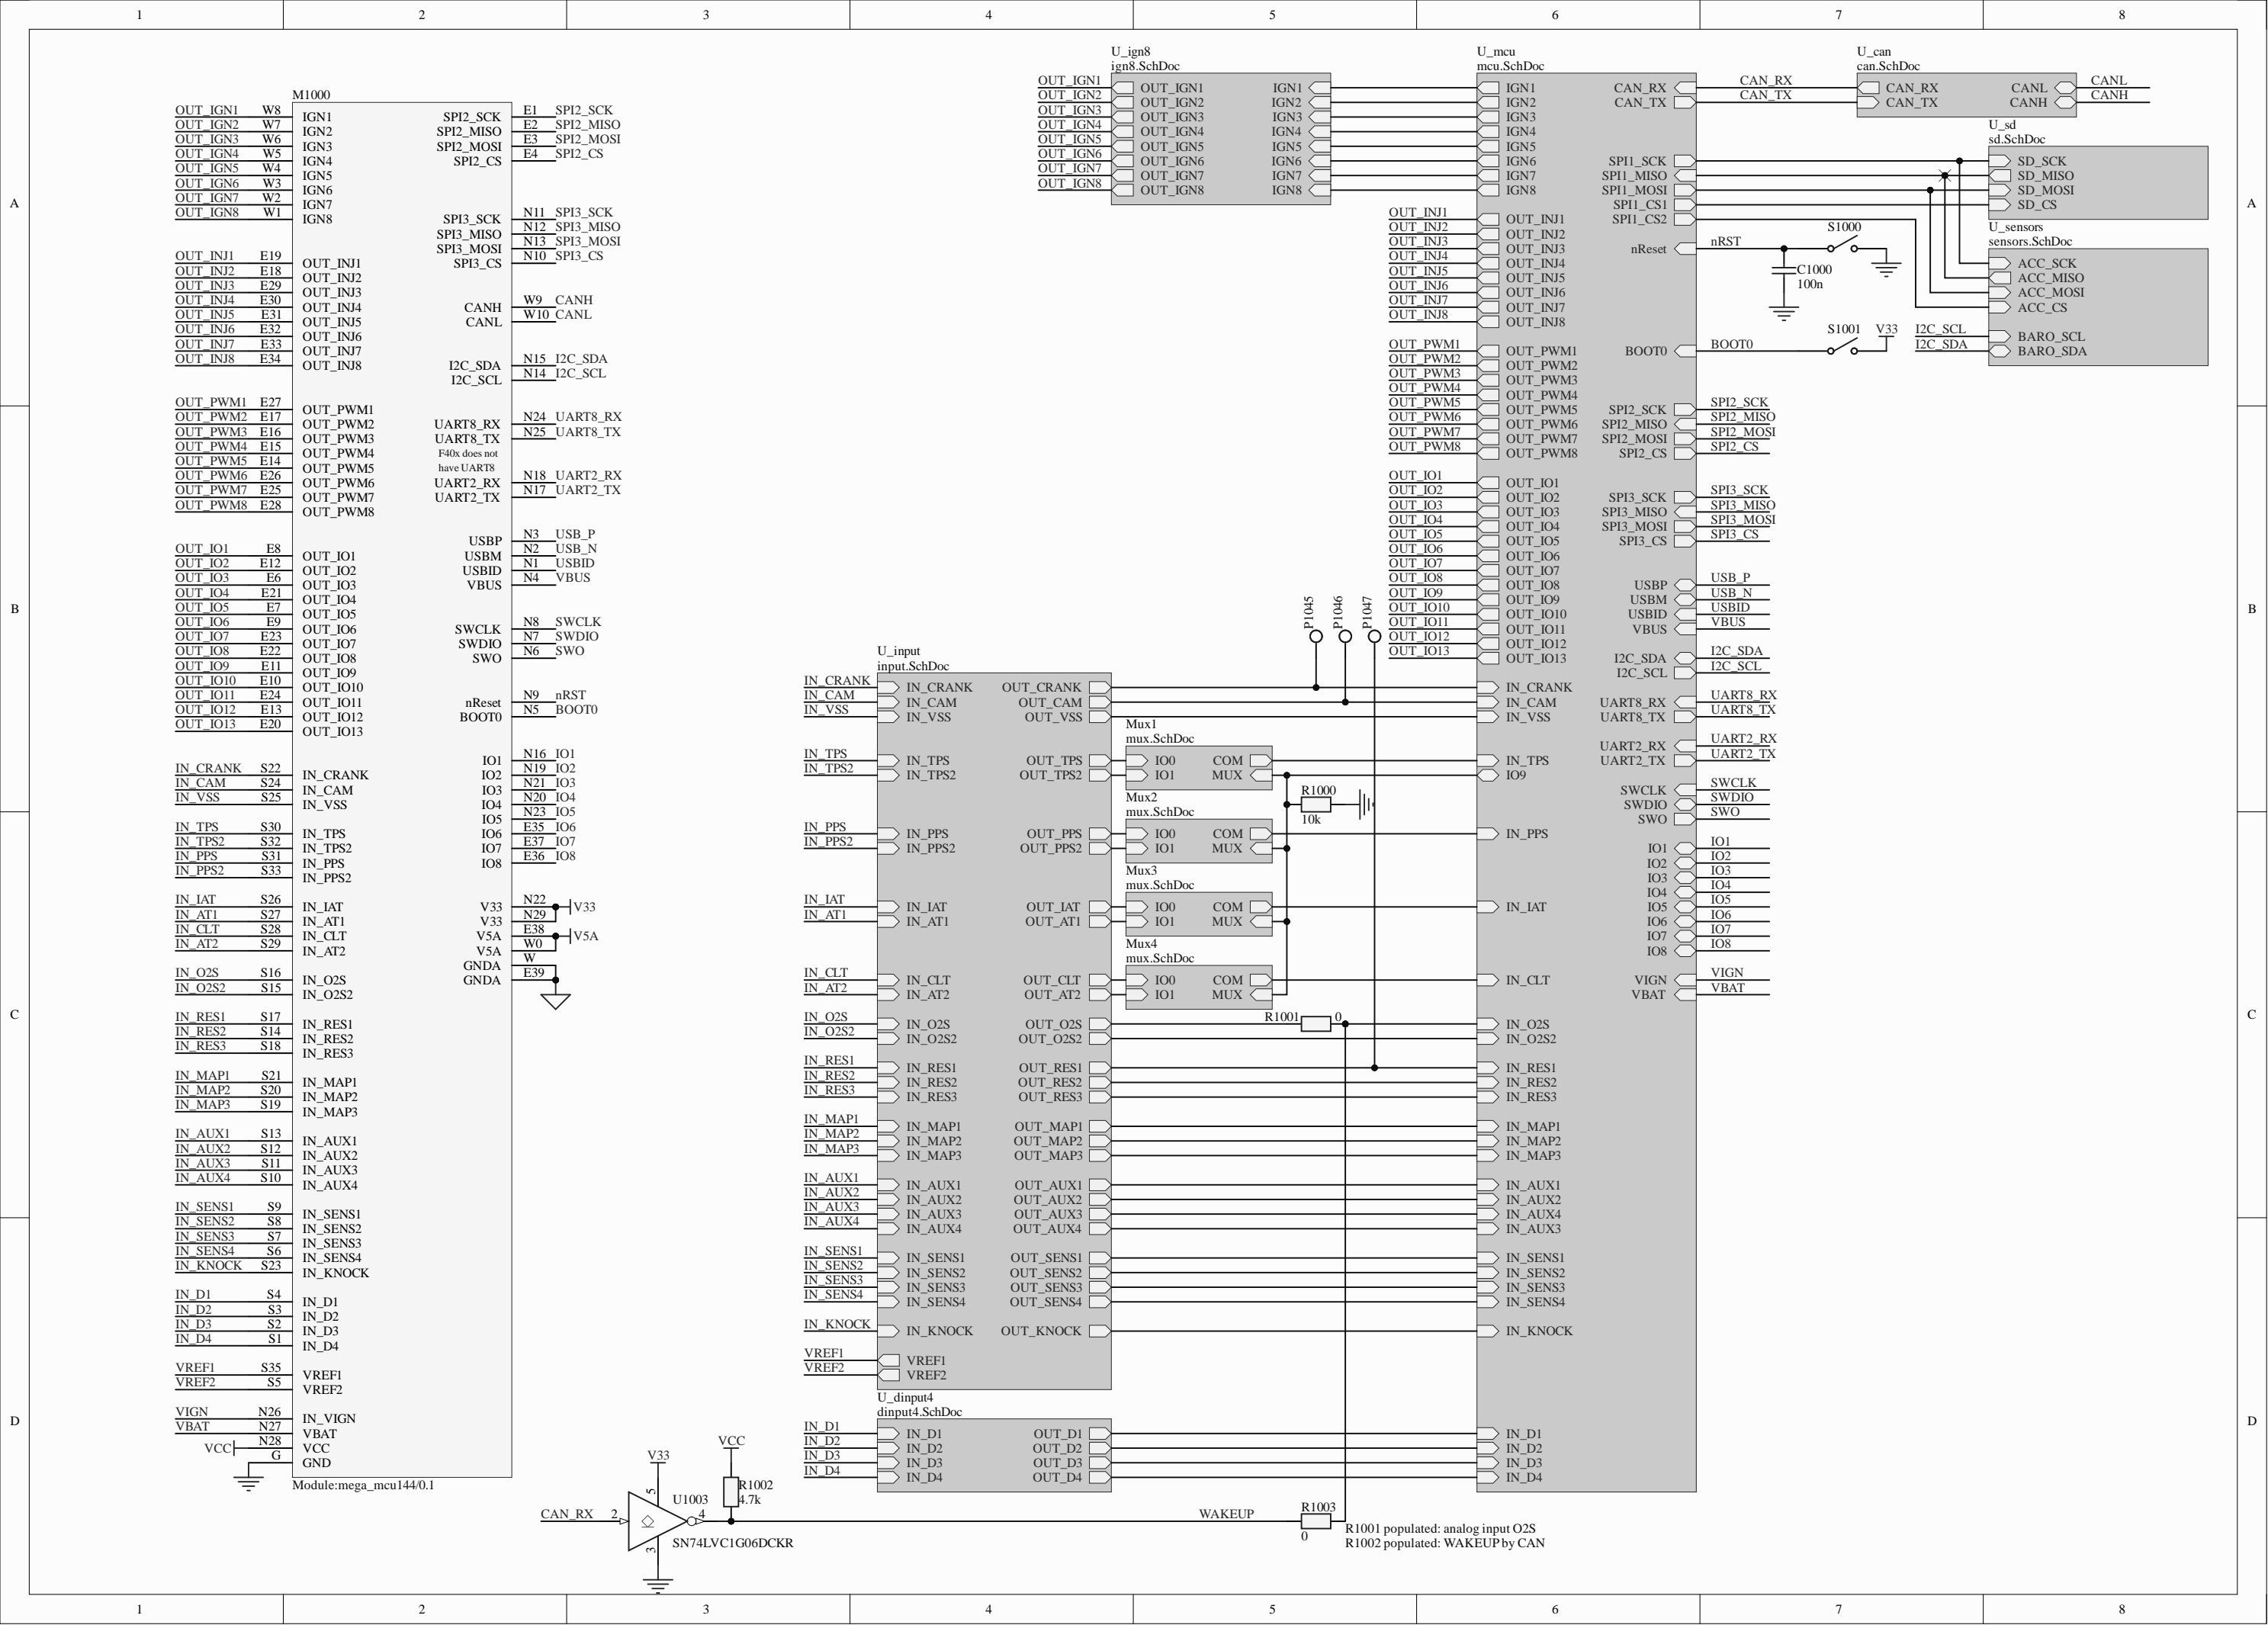
More accurate threshold for "raw" connection of VR sensors
